Access Compliance Report Public Rights-of-Way (Curb Ramps)

Main Street: BAINBRIDGE_AVE		Cross Street: WHIDBEY_DR		Location:	SE
ADA ID: RPRK211115120901	Ramp Type: Type 4 - Parallel	Initial Pass/Fail: Pass	Overall Compliance: No	Severity Score:	20
Codes/Mitigation Info/Possible Solution			Field Measurements/Component Compliance

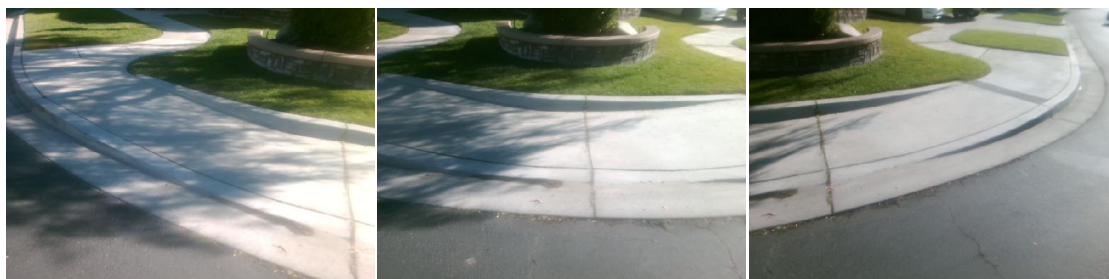
Compliance	Description	Data	Compliance	Description	Data
N/A	Ramp Length LT (in)	137	N/A	Ramp Length RT (in)	113
Yes	Ramp Width LT (in)	52	Yes	Ramp Width RT (in)	52
Yes	Ramp Run Slope LT (%)	6.8	Yes	Ramp Run Slope RT (%)	2.5
Yes	Ramp Cross Slope LT (%)	0.8	Yes	Ramp Cross Slope RT (%)	1.4
N/A	Landing Present	No	No	DWS Provided	No
N/A	Landing Length (in)	N/A	N/A	DWS Contrast	N/A
No	Landing Width (in)	N/A	N/A	DWS Length (in)	N/A
No	Landing Run Slope (%)	N/A	N/A	DWS Full Width	N/A
No	Landing Cross Slope (%)	N/A		DWS Offset Type	N/A
N/A	Landing Movement Obstructed?	No	N/A	DWS Offset Left (in)	N/A
	Landing Movement Type	Curb	N/A	DWS Offset Right (in)	N/A
N/A	Landing Shared	N/A			
N/A	Clear Space	Yes			
N/A	Clear Space To Crosswalk (in)	48			
N/A	Marked Crosswalk 1	No	N/A	Marked Crosswalk 2	No
	Crossing 1 Direction	NW		Crossing 2 Direction	SW
	Marked Crosswalk 1 Width (in)	N/A		Marked Crosswalk 2 Width (in)	N/A
N/A	Ramp Inside Crosswalk 1	N/A	N/A	Ramp Inside Crosswalk 2	N/A

Crossing 1 Slope (%)	2.3		Crossing 2 Slope (%)	2.4
	Crossing 1 Cross Slope (%)	2.4		Crossing 2 Cross Slope (%)	1.9
Yes	Gutter Ponding	No	Yes	Curb Slope	7.9
Yes	Gutter Lip Height (in)	0		Road Run Slope (%)	0.6
Yes	Gutter Run Slope (%)	2.9		Road Cross Slope (%)	2.6
Yes	Gutter Cross Slope (%)	0.1	No	Perpendicular Joint Present	No
Yes	Overall Surface Condition	Acceptable			
	Cross Gutter Present?	No		Spandrel Present?	No
	Replace Cross Gutter?	N/A		Replace Spandrel?	N/A

Remove & Replace Curb Ramp With Two New Directional Ramps or Equivalent.
